July 7, 2022

The Alliance of Automotive Innovation (Auto Innovators) is writing to provide comments and policy recommendations to NHTSA in advance of the agency's anticipated pedestrian protection rulemaking proposal that is expected to be published in the coming months.¹ These comments focus on several key issues identified in August 2018 National Highway Traffic Safety Administration ("NHTSA") GTR report entitled *"Vehicle Hood Testing to Evaluate Pedestrian Head Form Reproducibility, GTR No. 9 Test Procedural Issues, And U.S. Fleet Performance,"* and emphasize the importance of ensuring international harmonization.² Included is discussion on the impact of NHTSA's potential interpretation of unresolved issues within Global Technical Regulation (GTR) No. 9 that may result in inconsistent requirements between the United States and other parts of the world where similar requirements have already been adopted as part of regulatory or consumer information program evaluations.³ This will likely require U.S.-specific vehicle designs due to the lack of harmonization. Given the potential for regulatory misalignment, and the likelihood that proposed changes will have a significant impact

Figure 1: Regulation history for the definition of area calculation for HIC 1000 and 1700 zones (and resulting inconsistencies)

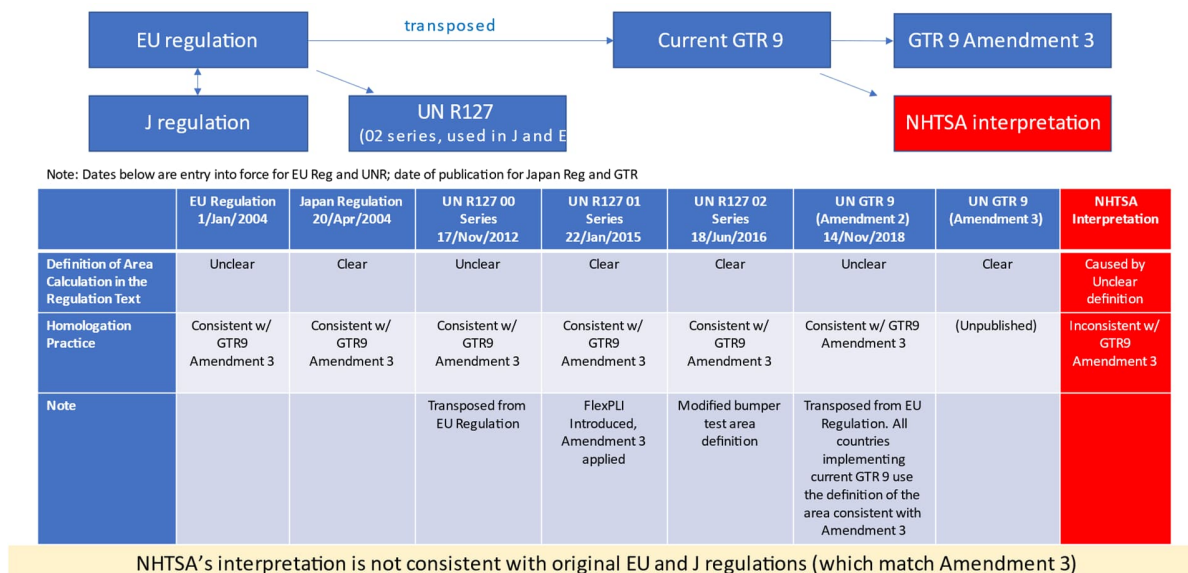
It is important that test procedures are harmonized and aligned. Inconsistency can have a significant, adverse impact on vehicle design. When conducting head impactor tests consistent with GTR No. 9, it is important to first mark up the vehicle to identify valid test areas. We recognize that the current requirements *as written* in GTR No. 9 are potentially open to interpretation with respect to the methodology (or mark-up procedure) for defining the corresponding HIC 1000 and HIC 1700 zones. However, despite this, there is clear alignment *in practice* for how the regulation is being applied through the test procedures that have been implemented in regions that have adopted the GTR. An example of this would be the Republic of Korea where KMVSS 102-2 was crafted per GTR No. 9 but in practice aligns with GTR No. 9 with the adoption of Amendment 3. In an attempt to resolve possible differences between the regulatory text and the corresponding test procedure, a proposed *clarifying amendment* was introduced (referred to as Amendment 3) to update GTR No. 9.⁸ These issues are summarized and described in Figure 1 and 2 below.

Figure 3: Comparison of the HIC 1000 area ratios when applying markup procedures from Amendment 3 and the expected NHTSA interpretation of current GTR No. 9

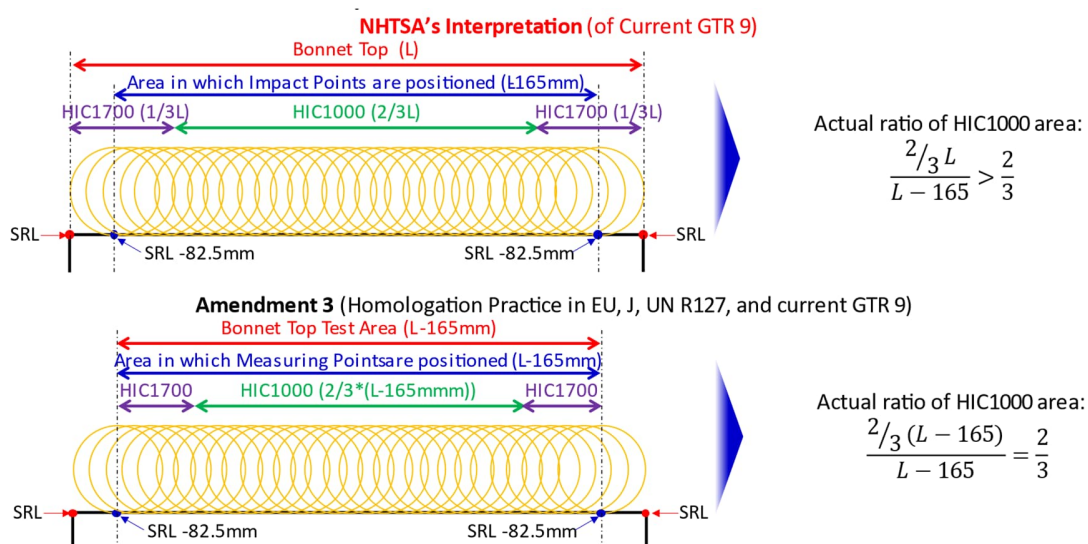
Auto Innovators recommends that the “mark-up” approach discussed in the agency’s 2018 report should not be pursued.⁹ If the mark-up procedure approach adopted in NHTSA regulation is inconsistent with the current GTR No. 9 test procedure, in practice this could potentially result in undefined HIC 1000 and HIC 1700 zones, or circumstances where the ratio of HIC 1000 zones exceed 2/3 of the testable area. This is illustrated in Figure 3, below, using a simplified 2D representation of the width of a vehicle hood. Miswording in the current GTR No. 9 leads to interpretation of the area requirement that is different from the original concept of GTR No. 9 to prescribe 2/3 and 1/3 area ratios for HIC 1000 and HIC 1700 zones, respectively. Similar issues would also likely arise if the agency were to adopt a hybrid approach that blends requirements from the GTR No. 9 and UN Regulation 127 test procedure.

To ensure greater harmonization, NHTSA should align with how GTR No. 9 is being implemented in other markets in terms of mark-up procedure. We encourage the agency to base its proposal on the GTR 9 with consideration for proposed clarifying Amendment 3, and to work with its international partners to ensure favorable resolution within the UNECE process.

Figure 4: Sensitivity of the actual ratio of the HIC 1000 area to the width of a vehicle, when comparing markup procedures from Amendment 3 and the expected NHTSA interpretation of current GTR No. 9

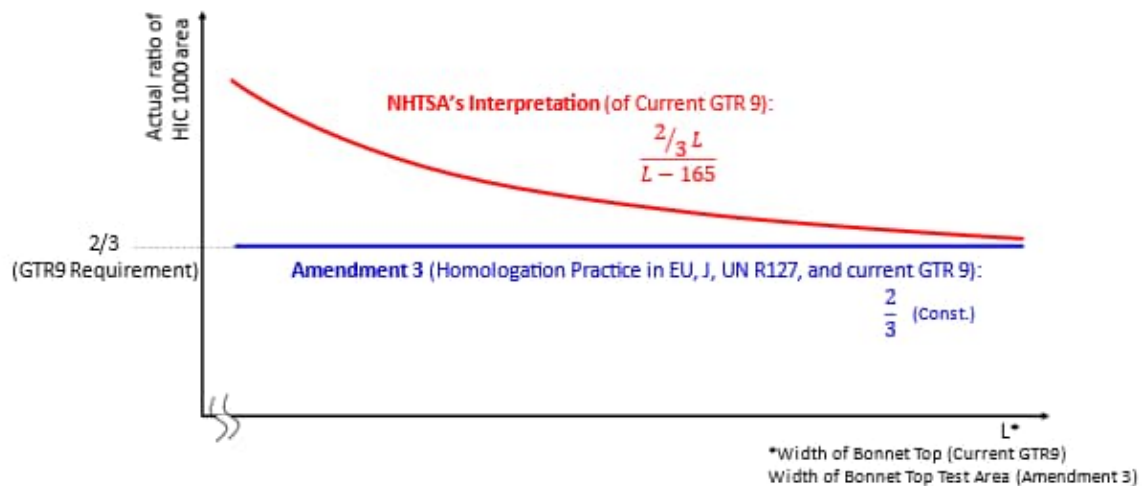
Figure 4, below, further demonstrates that for vehicles with smaller, narrower front ends, the actual ratio of the HIC 1000 area can become substantially larger than the fundamental 2/3 requirement in GTR 9. This inappropriately drives more stringent requirements for smaller vehicles and would have the counterintuitive effect of encouraging larger vehicles because of the comparatively lower ratio of HIC 1000 to 1700 zones in relation to the overall size of the vehicle front end. Above all, this creates significant concerns for objectivity and departs from the fundamental concept of defining 1/3 and 2/3 ratio zones for HIC 1700 and 1000 areas.

Figure 5: Definition of Impact Point (Current GTR9)¹⁴ and Measuring Point (Amendment 3)¹⁵

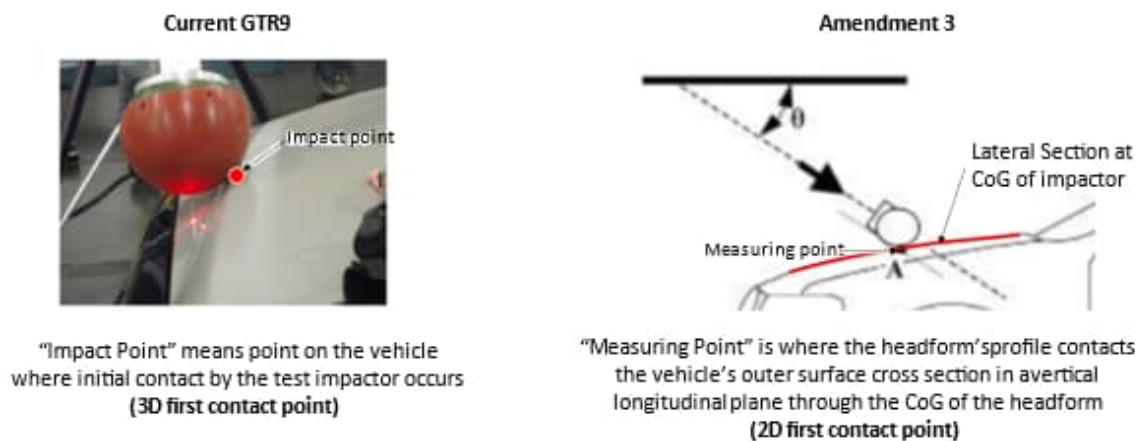
The NHTSA report states, "Different interpretations of the head impact point could affect HIC outcome in a test, depending on the geometry/contour and under hood structures in the vehicle."¹¹ This statement is particularly relevant with respect to the proposed use and application of the 3D POFC method, where the interpretation by the agency introduces unnecessary complexity as well as several other issues as described below.

Figure 5 illustrates the difference between the definition of “Impact Point” (based on the 3D POFC) and the “Measuring Point” (using the 2D method) ^{12,13}

The aforementioned issues with the 3D POFC do not exist for the 2D method. We therefore strongly urge the agency to adopt the 2D approach as it is significantly more straightforward, limits unnecessary test burden, ensures repeatability and reproducibility, better guarantees that impacts occur within defined testable areas, and is more closely aligned with the intent of GTR No. 9.

Figure 6: Challenges with 3D POFC Method [Source TFPP3-1-03]

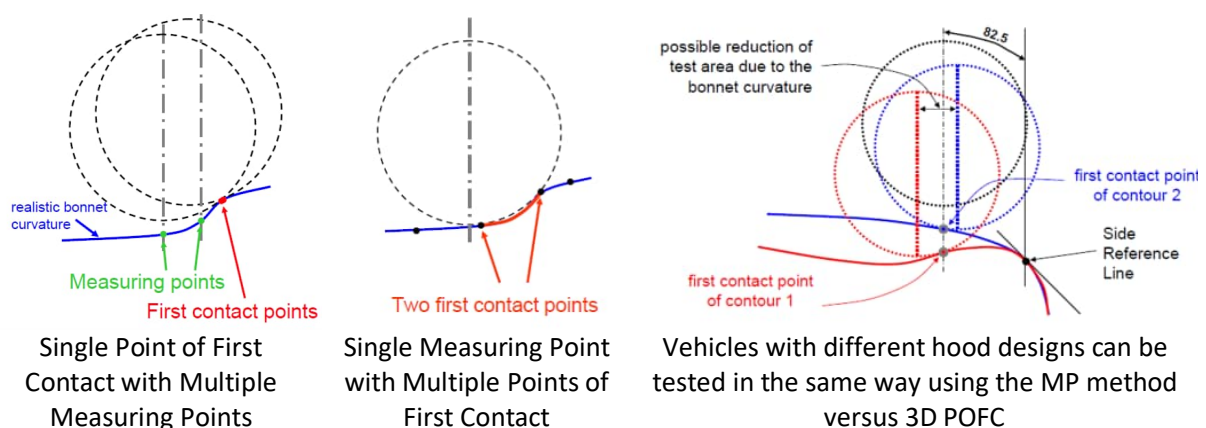
In addition to challenges outlined in the previous section, the 3D POFC method also introduces repeatability and reproducibility concerns whereby a “Point of First Contact” could be associated with multiple impactor positions as outlined in Figure 6, below. In some cases, depending upon the structural profile of the hood, areas where multiple POFCs may exist results in zones that cannot be reliably assigned to a single point. Areas where a test cannot be assigned to one single point may need to be considered as “unassignable,” particularly where they overlap HIC 1000 and HIC 1700 zones.
